Proposed Alterations to Second Stage PUD for Capitol Crossing / Holy Rosary Church

02/04/16

Preliminary note on proposed massing and materiality:

F Street / South Elevation

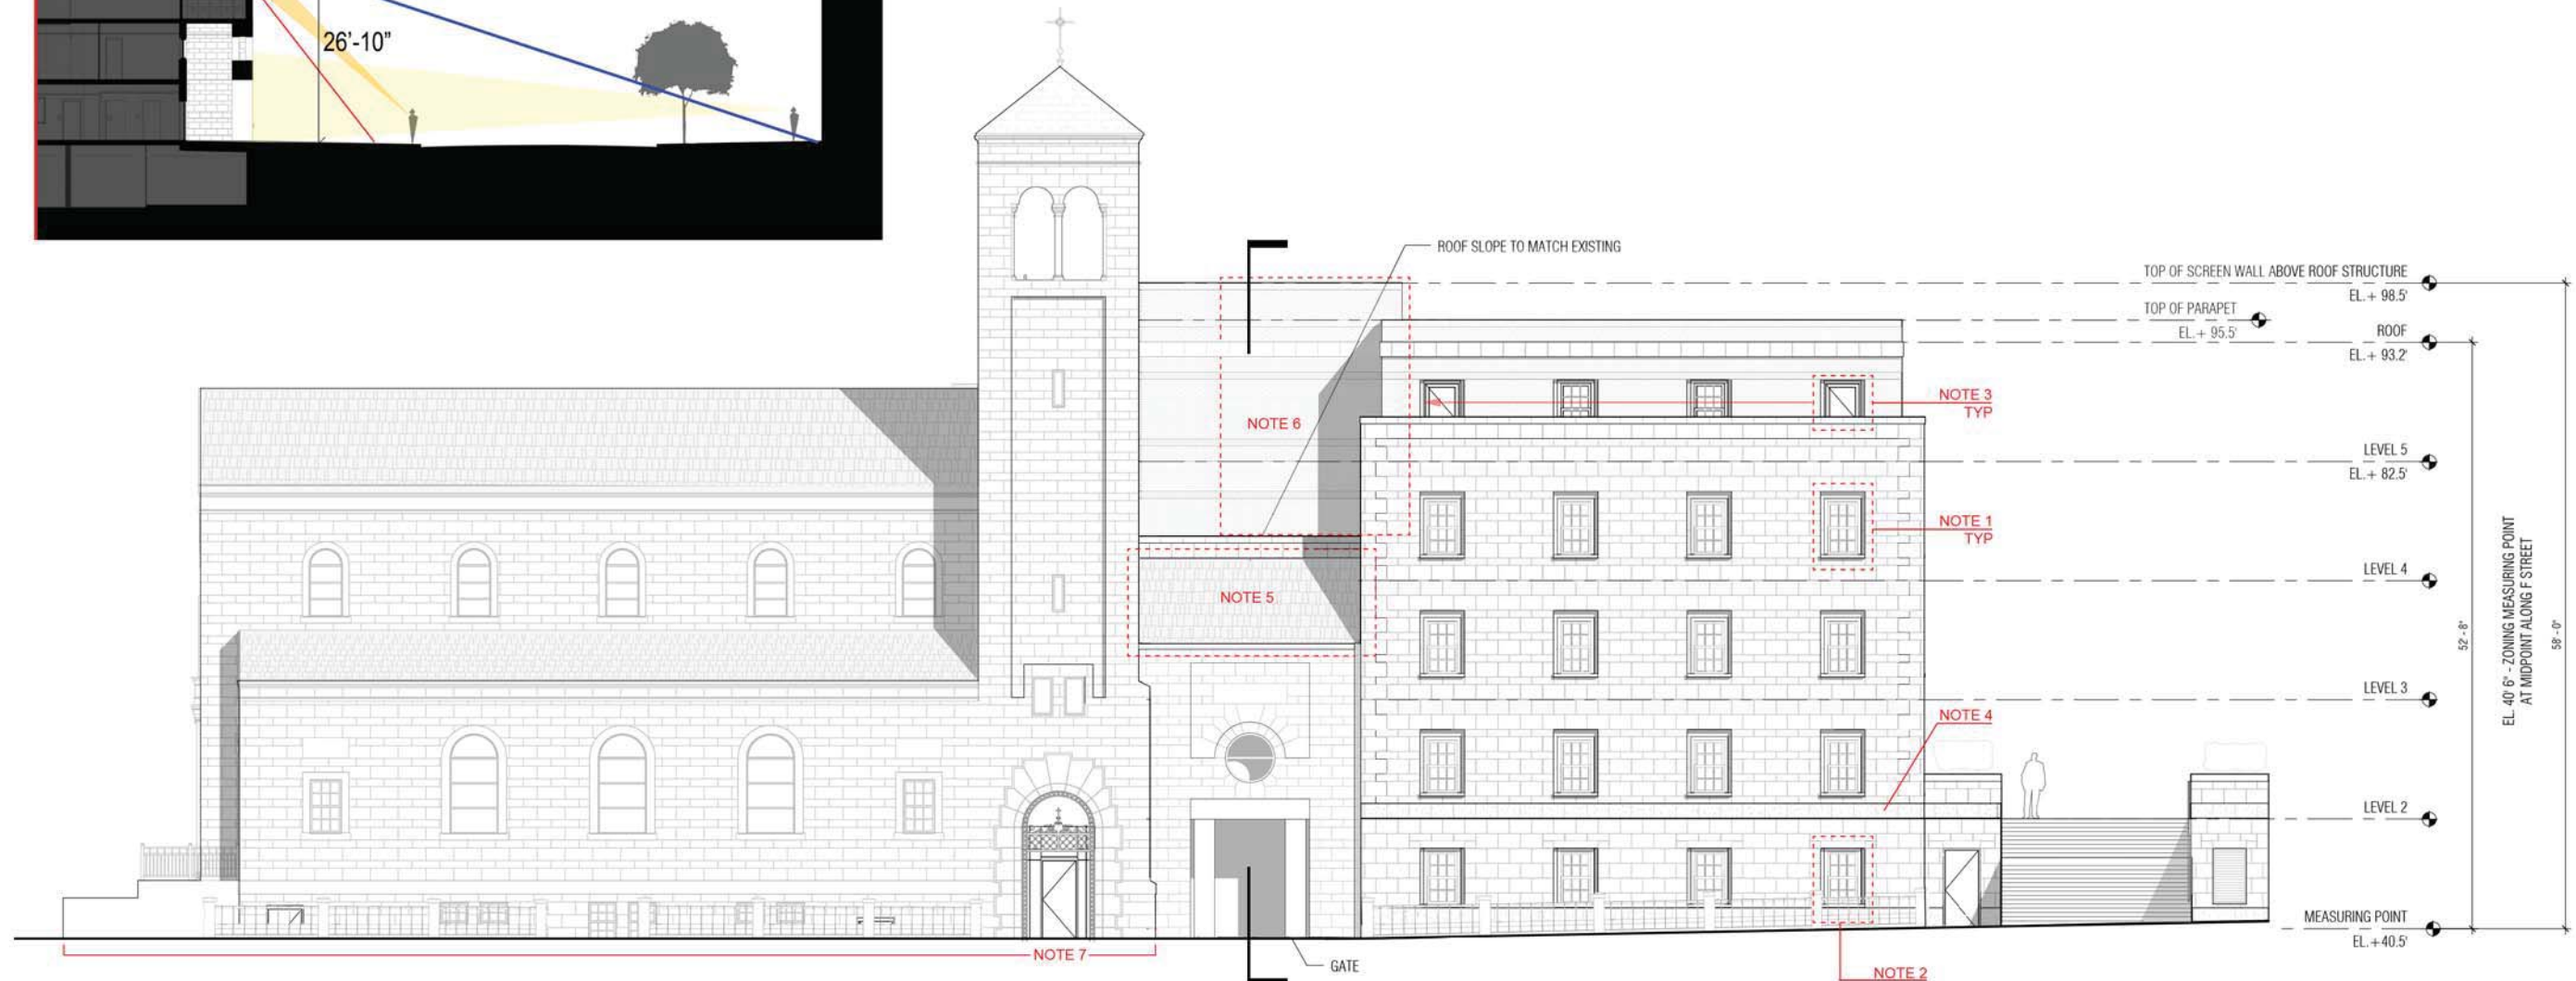
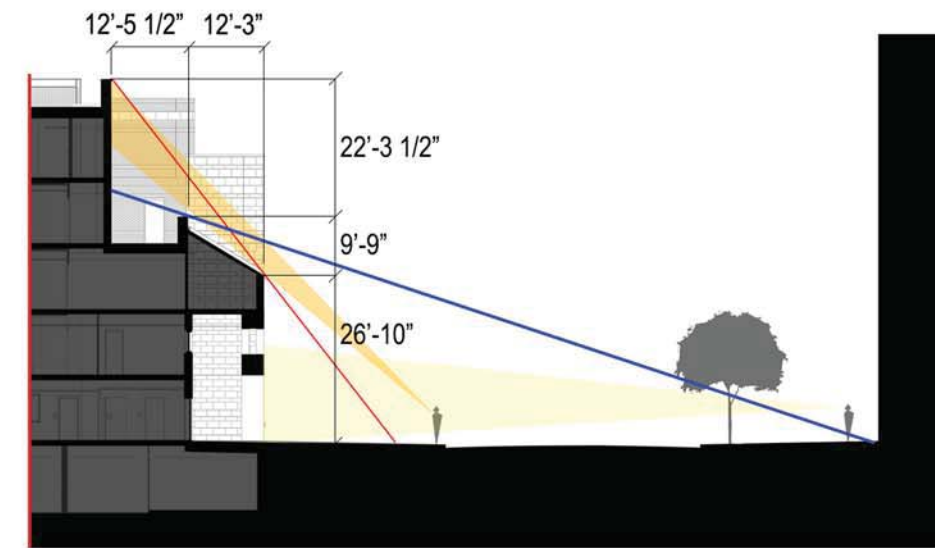
1. The south (F Street) facade retains punched windows with divided lites and a recessed surround detail.
2. The ground floor windows have been altered to match the windows above. The pairing of smaller windows, as shown in the PUD, is appropriate for half-basements like the Sanctuary's basement to the east.

3. The window/door size on the South facade's 5th floor have also been increased in width to become code compliant and decreased in quantity to align with the windows below and to comply with the internal program.

4. F Street facade now shows a granite belt course instead of the metal belt course shown in the prior PUD. Contrast in materials and texture remains.
5. The new slate roof matches the slope of the previous sloped slate roof.

6. The window wall above and behind the entrance volume has been removed.
7. The existing Sanctuary including existing ornamentations, door, surround, Bell Tower recess, and windows are accurately modeled.

East Elevation

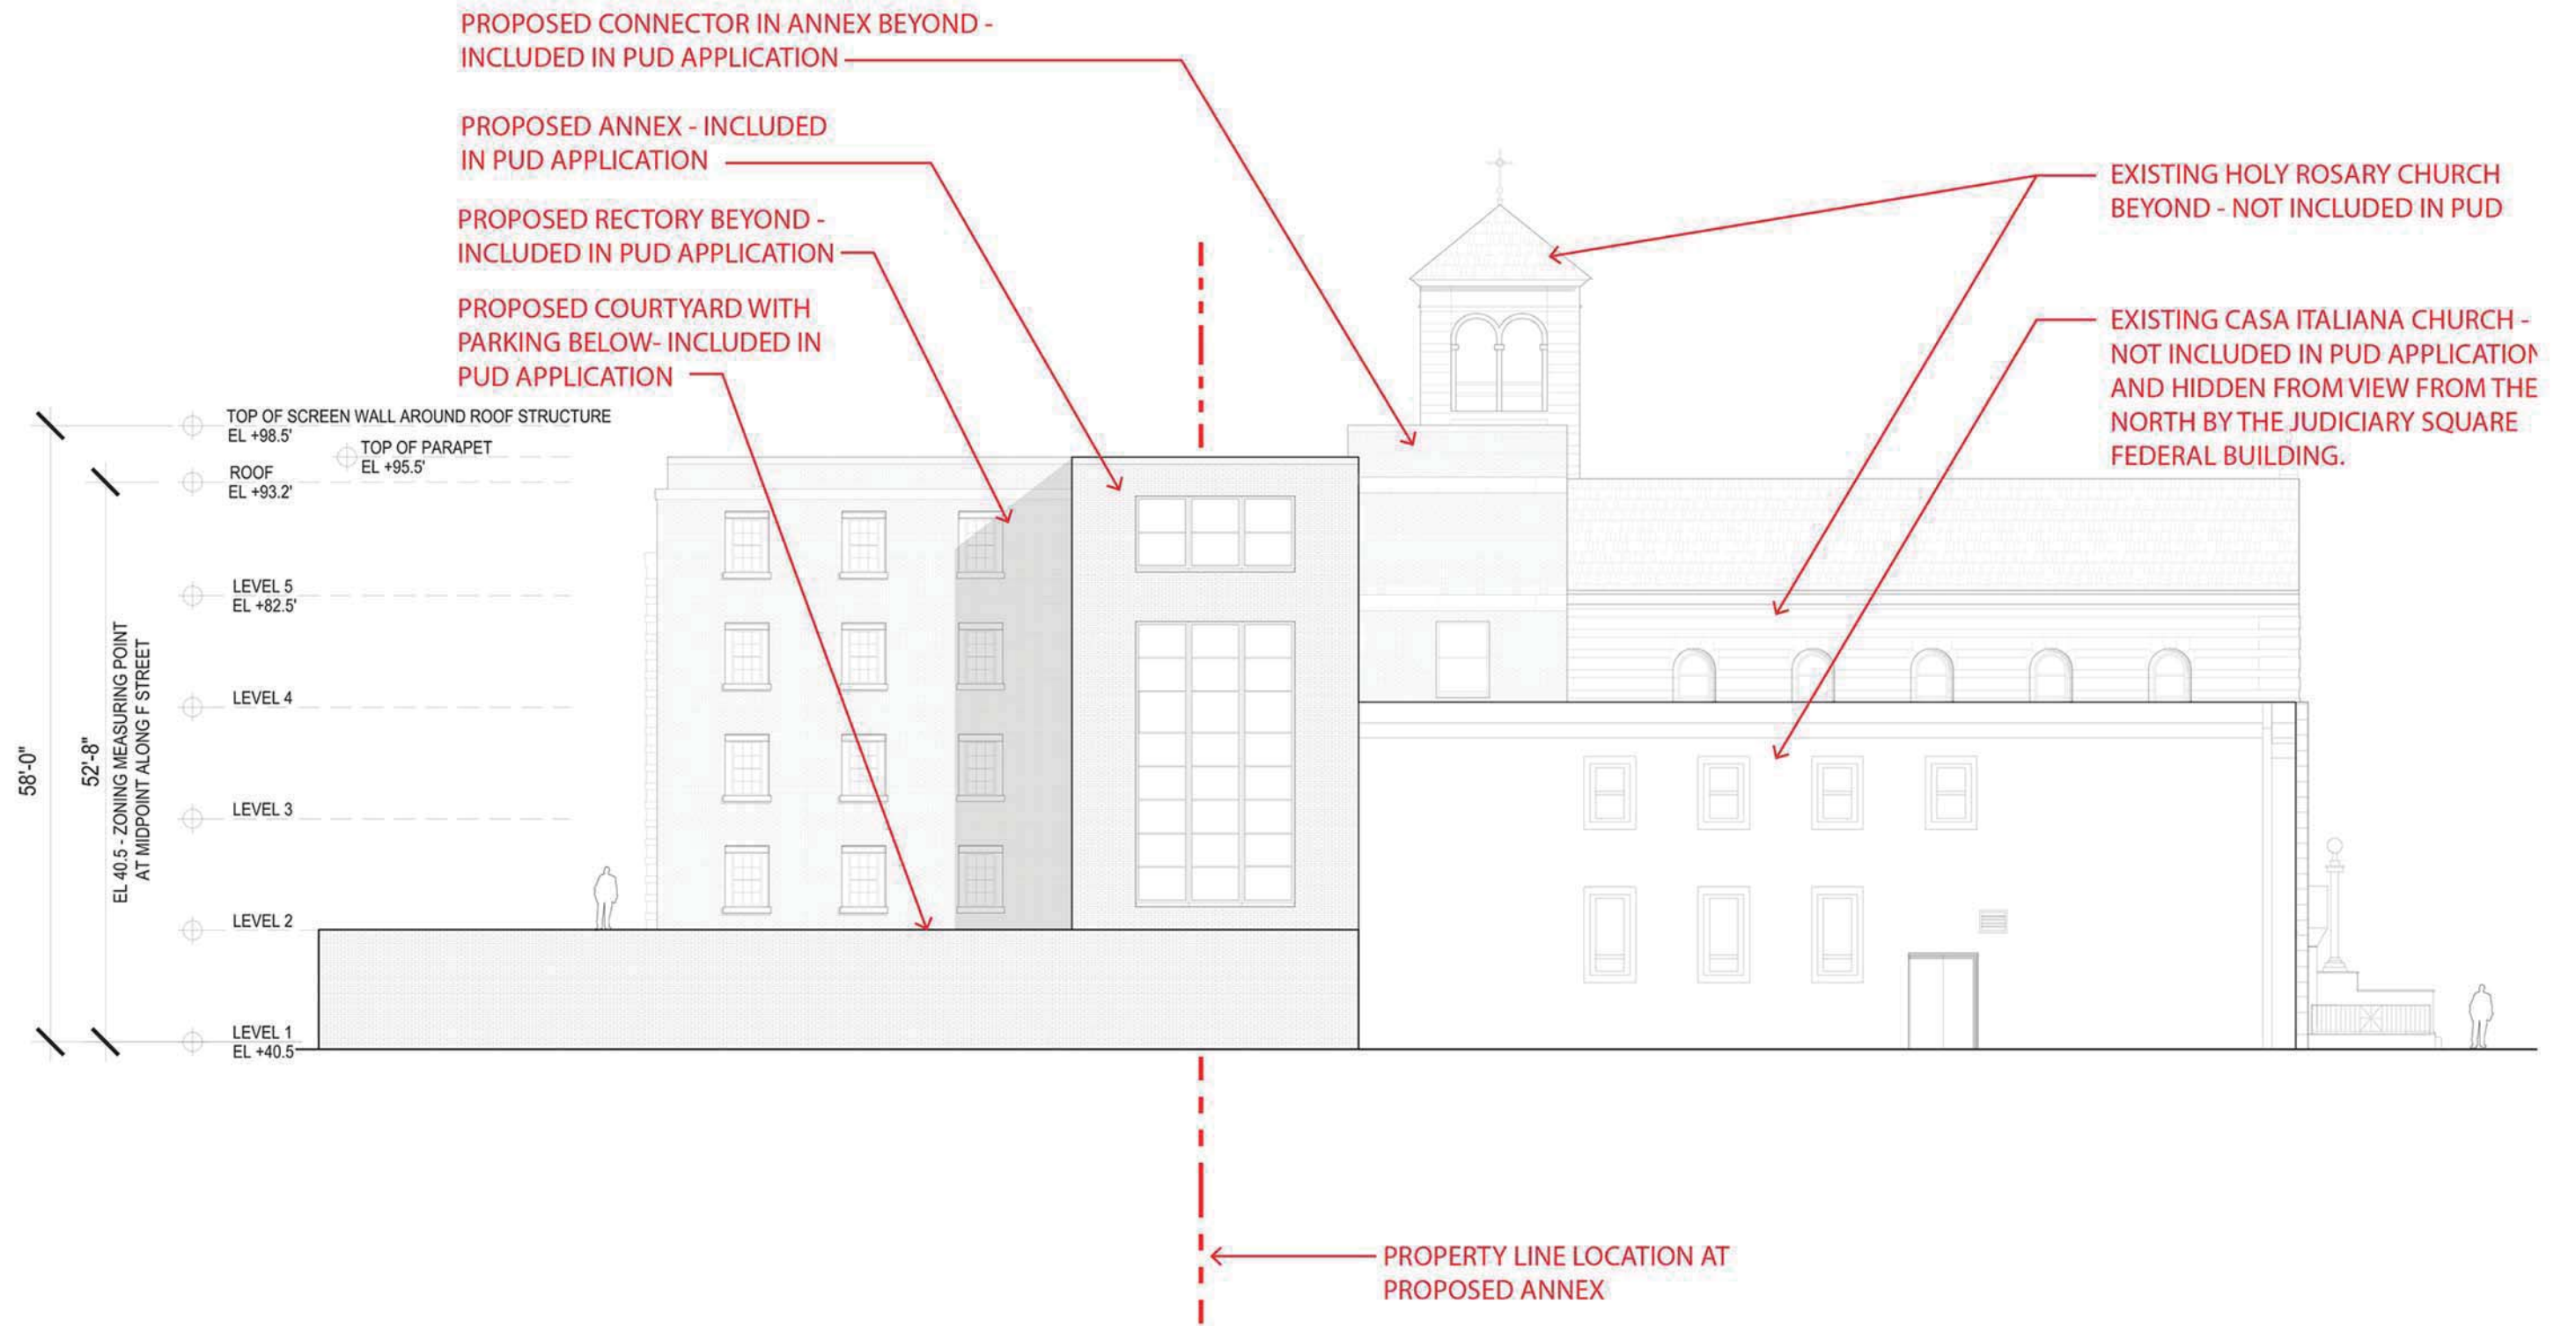
1. Details more refined based on further field evaluation.
2. The classroom windows remain grouped on floors 2-4 with aligned punched openings at the 5th floor. The arrangement and size of the windows has been modified to accommodate toilet rooms and program requirements. The overall design sensibilities remain intact.
3. A granite base to match the south elevation is shown.
